Featured Products Bulletin

RESISTOR NETWORKS

Laser Marking on 4600X Series

Typical Marking Before Change

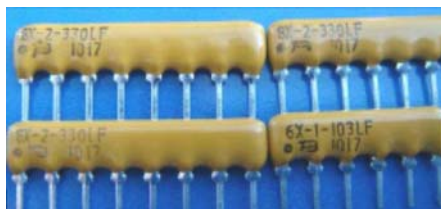
Riverside, California - June 29, 2010 - Bourns will begin laser marking the [4600X Series](#) of resistor networks on all part numbers starting with date code 1027.
